Service Bulletin

No. : MZ08-014

Model: SR8002

Subject: Information on modification of HD Radio Module and Software

**POS.NO.60
HD RADIO MODULE
for SR8002/U1B**

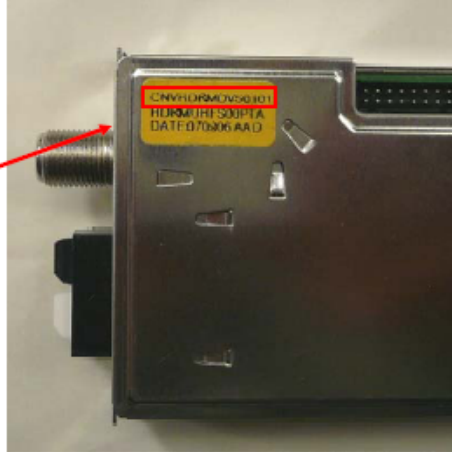
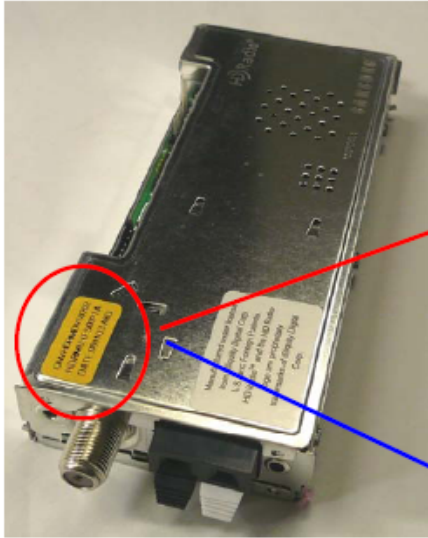
Symptom: The HD Radio Module has been modified to be more capable of receiving all-digital broadcasting, which will start in the near future. The current module built in products that are already in use does not always need to be modified, because it is already capable enough. (In replacing the current module with a new one, please be sure to check its compatibility with the existing software. This combination can cause the Auto Seek Level and the FM Switching Level to be higher than they ought to be.)

1. In replacing POS. NO. 60 Part no: 90M-AV000580R (CNVHDRMDUS0101) with a 90M-AV000590R (CNVHDRMDUS0202), also upgrade the HD Radio CPU software to Version "HDRV07111401" or a newer version.
2. The HD Radio CPU software of Version "HDRV07111401" can work with the old module Part no: **90M-AV000580R** (CNVHDRMDUS0101) without any problems. (It has backward compatibility.)
3. The old HD Radio Module Part no: **90M-AV000580R** (CNVHDRMDUS0101) has no performance problem with all digital broadcasting and does not need to be replaced with a new one, unless the module has broken down and needs to be replaced.
4. For "how to update the HD Radio CPU" software, please see the Service Manual on Page 35 (Mode 4).
5. For "how to differentiate the old and new HD Radio Modules", please see the following pages of this bulletin.

OLD
Type no: CNVHDRMDUS0101
Part no: 90M-AV000580R

NEW
Type no: CNVHDRMDUS0202
Part no: 90M-AV000590R

* HD Radio CPU software will update to Version: HDRV07111401
